SERVICE BULLETIN

No. 525

Piper Aircraft Corporation

Subject: Pilot/CoPilot Seat Latch Mechanism Modification

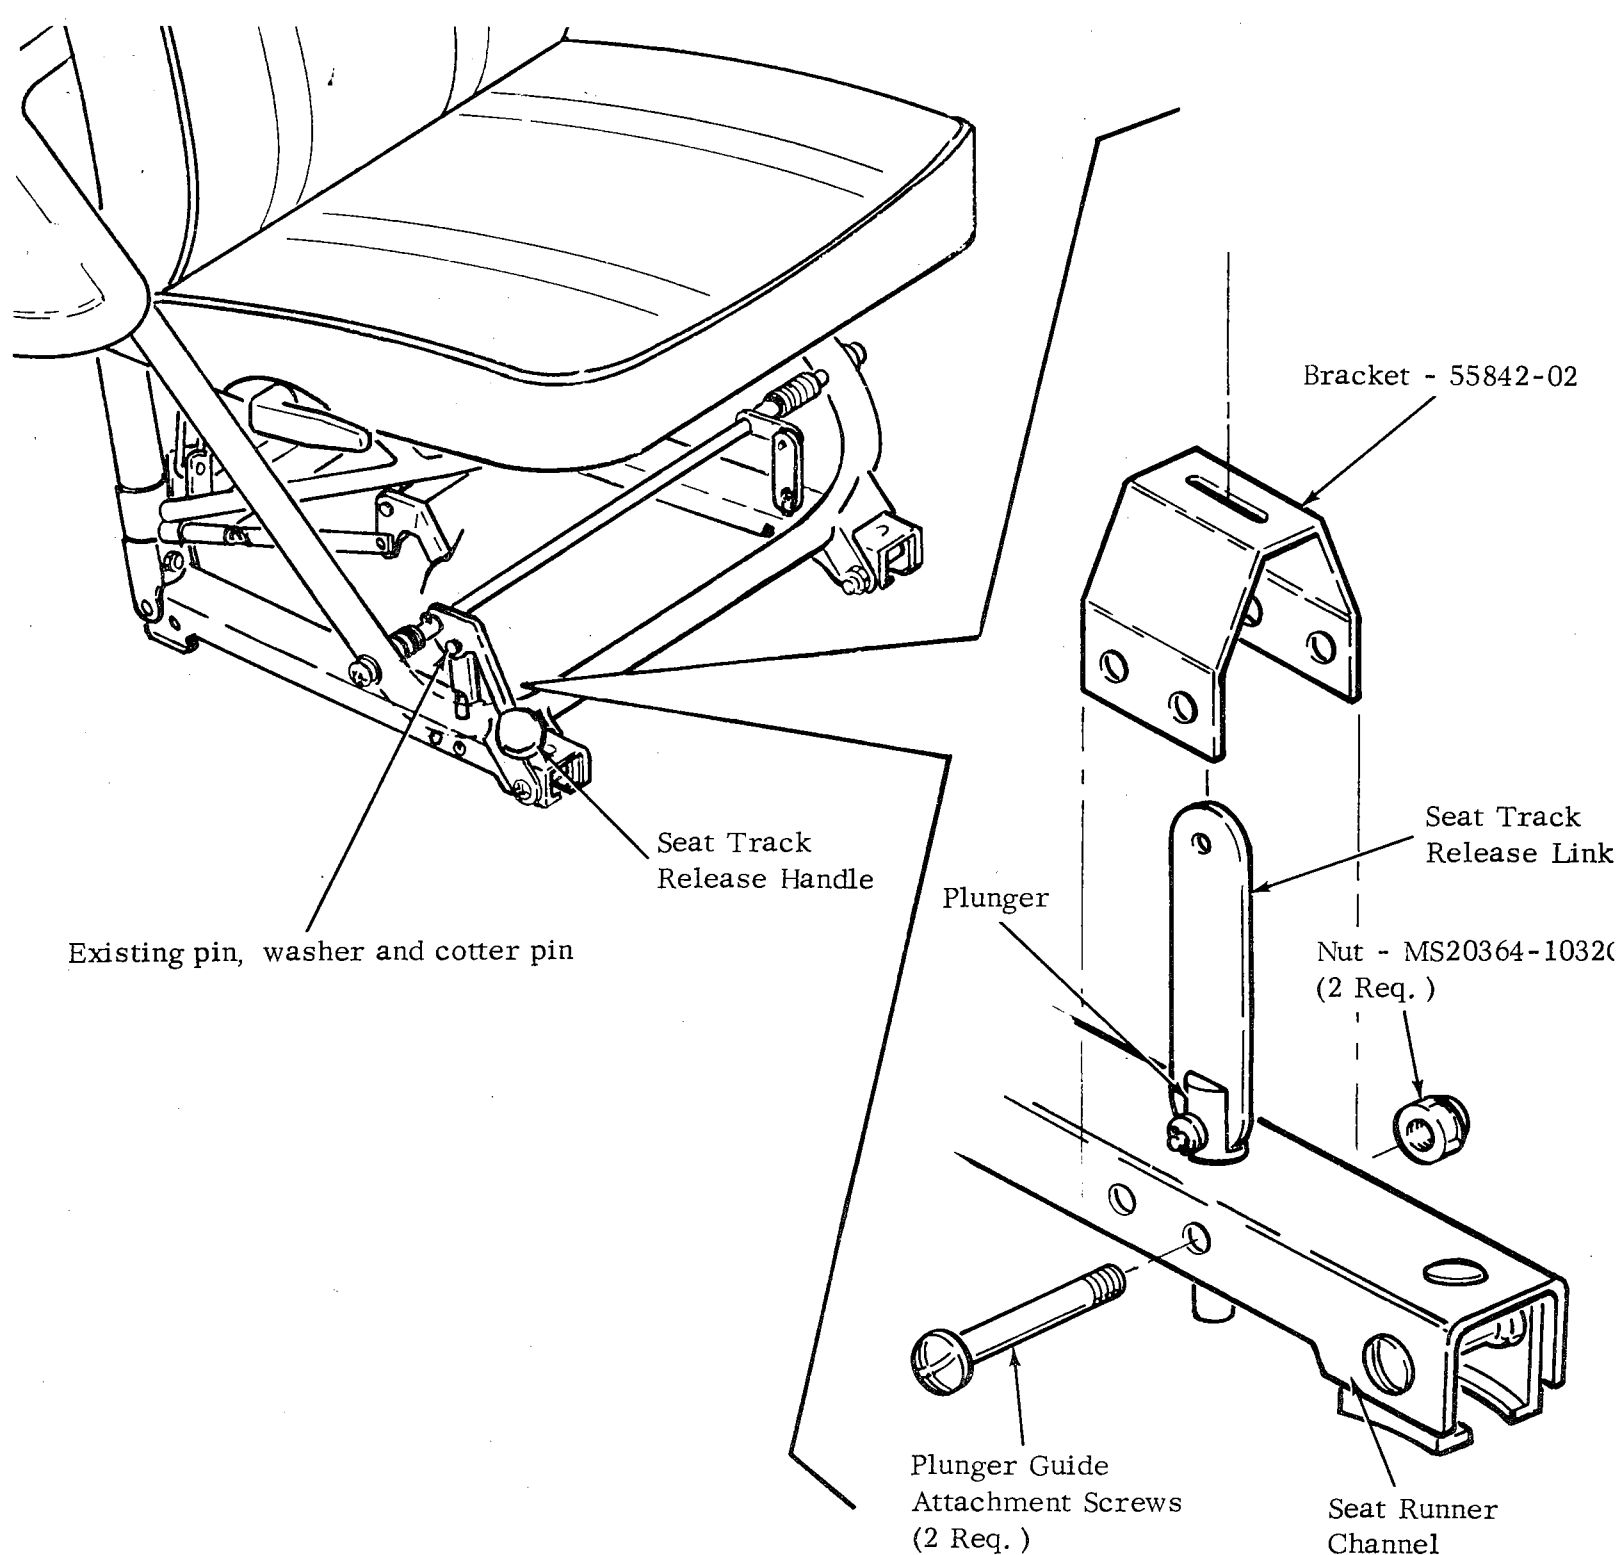
Purpose: A report has been received from the field describing a condition in which the pilot's seat latch mechanism plunger jammed in the "up" position, failing to relock upon release of the seat adjustment lever. This condition could permit inadvertent fore and aft travel of the pilot/copilot seat.

This service release provides material and instructions to install a bracket over the plunger/ seat track release link assembly to prevent excessive upward movement of the plunger, thus insuring relocking of the plunger when the seat adjustment lever is released.

Instructions: Refer to attached sketch/instruction sheet for seat frame bracket installation details.

Material Required: One (1) each per seat (i.e., maximum two per aircraft) - reference Serial Numbers Affected, above - Piper part no. 55842-02 Seat Frame Bracket.

1. Remove the pin, washer and cotter pin attaching the seat track release link to the seat track release handle, as shown above. Retain hardware for reinstallation. Do not remove link and plunger assembly from seat runner channel.
2. Remove the two plunger guide attachment screws as shown above. Retain screws for reinstallation and discard cap nuts.
3. Install bracket 55842-02 to seat runner channel, as shown above, using the two existing screws and two new MS20364-1032C nuts (procure nuts locally).
4. Attach seat track release link to seat track release handle using existing hardware as shown.
5. Make proper logbook entry of Service Bulletin 525 compliance.
